Product Change Notification / KSRA-09NSTT965

CCB 4251 Final Notice: Qualification of MTAI as an additional final test site for selected Atmel ATF16V8Bxx device family available in 20L PDIP package.

PCN#:KSRA-09NSTT965

CCB 4251 PRE AND POST CHANGE SUMMARY

TUBE

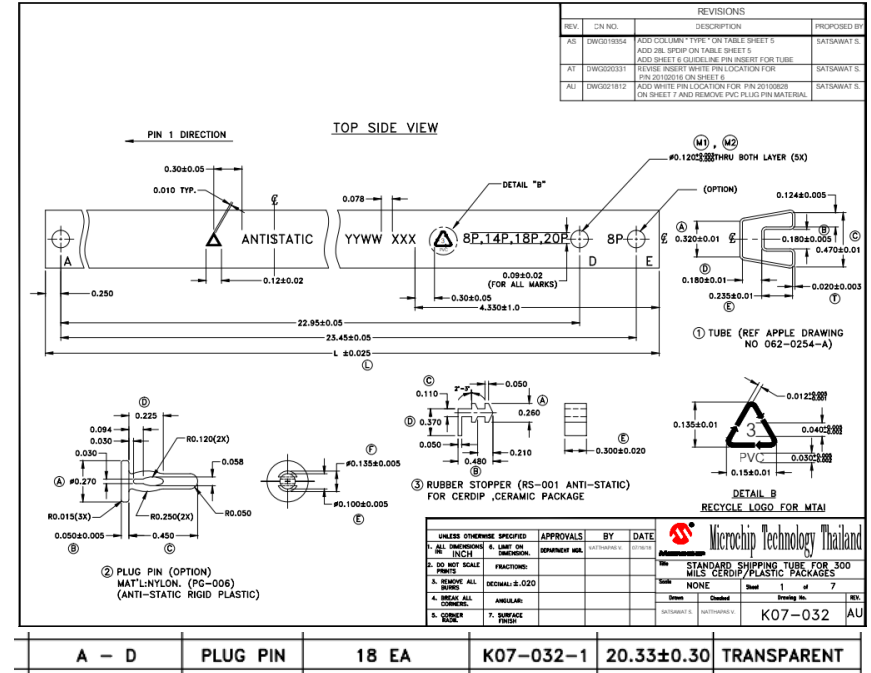
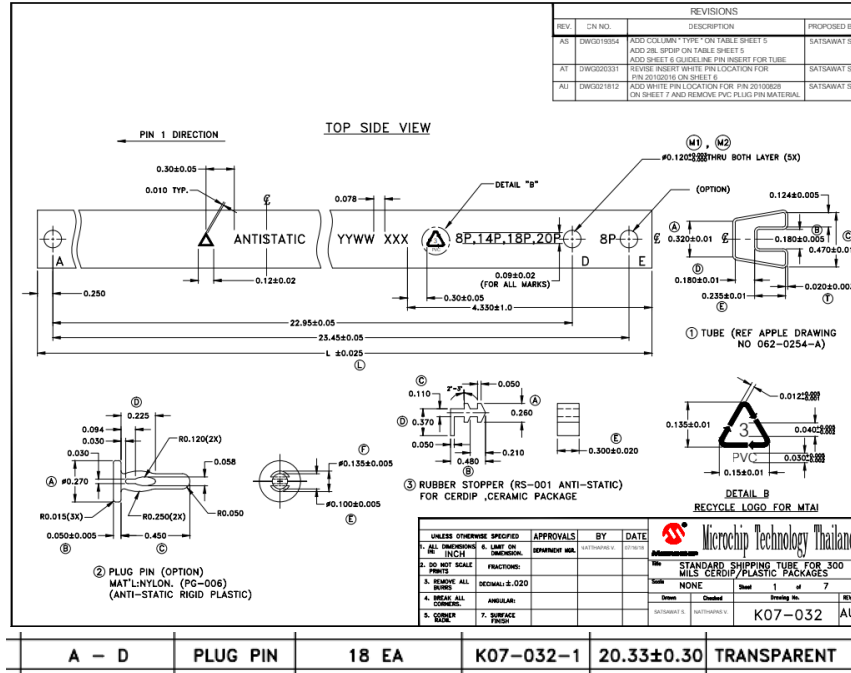
MPHL

MTAI

Plant	Dimension A	Dimension B	Dimension C	Length	Thickness	Color
MPHL	0.180+/-0.01in	0.320+/-0.01in	0.235+/-0.01in	20.33 in	0.020+/-0.003in	Transparent
MTAI	0.180+/-0.01in	0.320+/-0.01in	0.235+/-0.01in	20.33 in	0.020+/-0.003in	Transparent

TUBE Packing method for Package

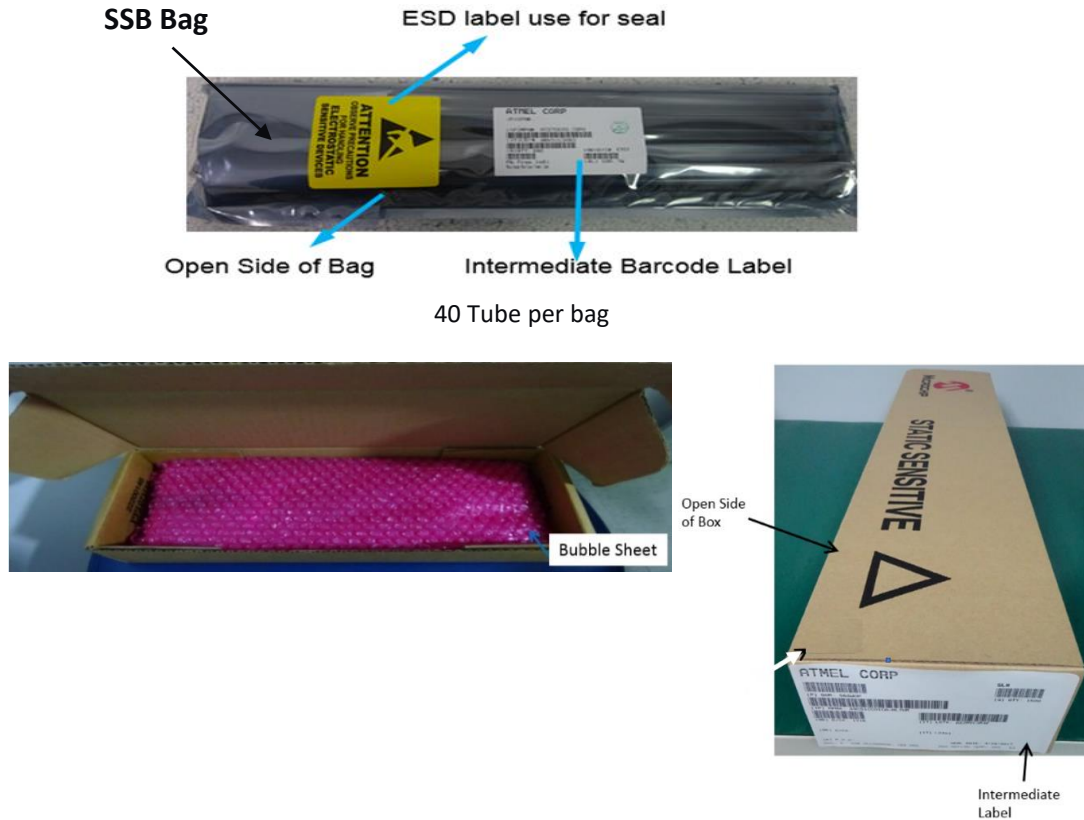
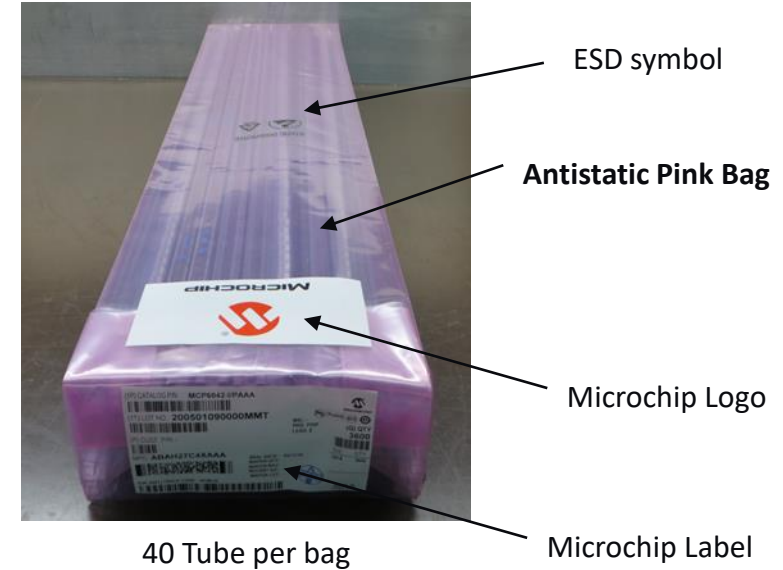
MPHL

MTAI
